KINGSTON FOSSIL PLANT

DREDGE CELL RESTORATION

TVA/COO		FORM A - DESIGN CHANGE NOTICE			Page 1 of 2	
1. a. DCN Type <input type="checkbox"/> Base DCN <input checked="" type="checkbox"/> PIC for Base/ Parent DCN No.: KIF-05-1090		b. Class Routine Design Change <input type="checkbox"/> Documentation Only <input type="checkbox"/> Material Equivalency <input type="checkbox"/> c. Advance Authorization <input checked="" type="checkbox"/> Yes <input type="checkbox"/> No		2. DCN No. KIF-05-1090 <i>12-99</i>	Rev. 0	3. Plant/TL/SUB/Facility KIF
		3. Unit/TL/SUB No. 1-9		4. System(s) 14,114

**APPENDIX 2 TO FORM C DCN KIF-05-1090
KINGSTON FOSSIL PLANT DREDGE CELL RESTORATION**

DETAIL L91
EMERGENCY SPILLWAY
N.T.S.

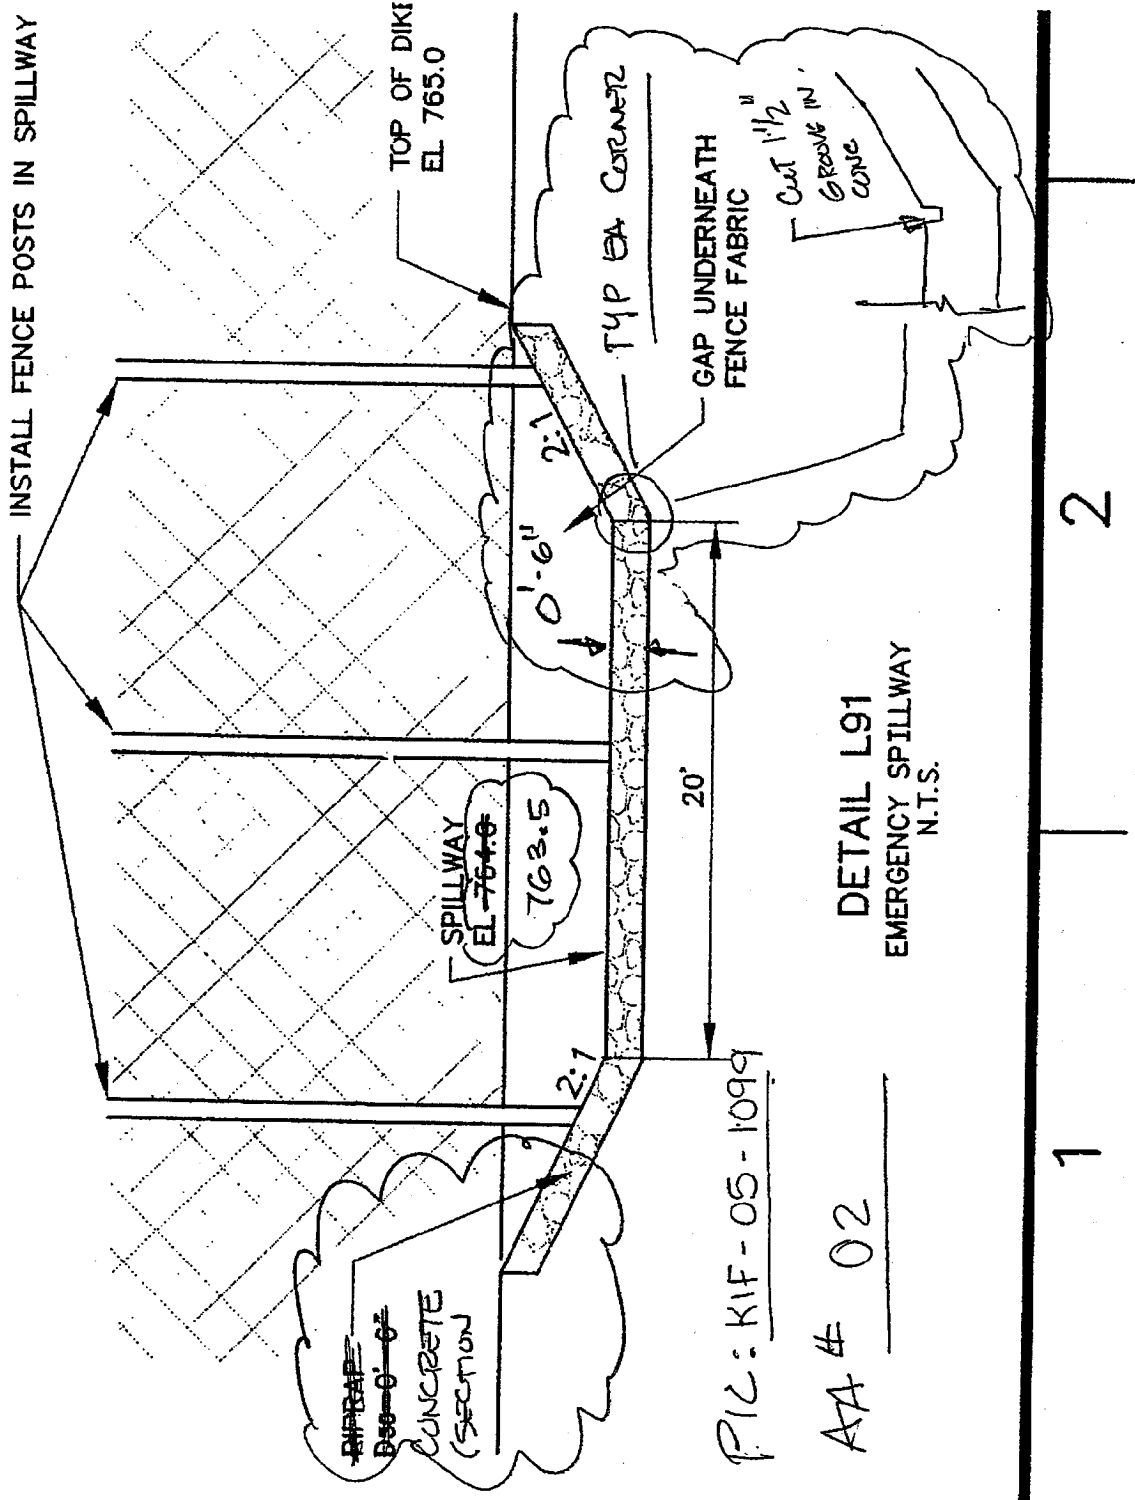
Block 6 - Requested Change

Revise spillway as shown. Due to a difference in topography (pre construction vs. post construction), the spillway needs to be lowered to ensure the upstream ditch does not overtop. The pond will not discharge a 25-yr storm event with the pumps running.

Block 11 - Approved Change

See revised DCA sketches to this AA
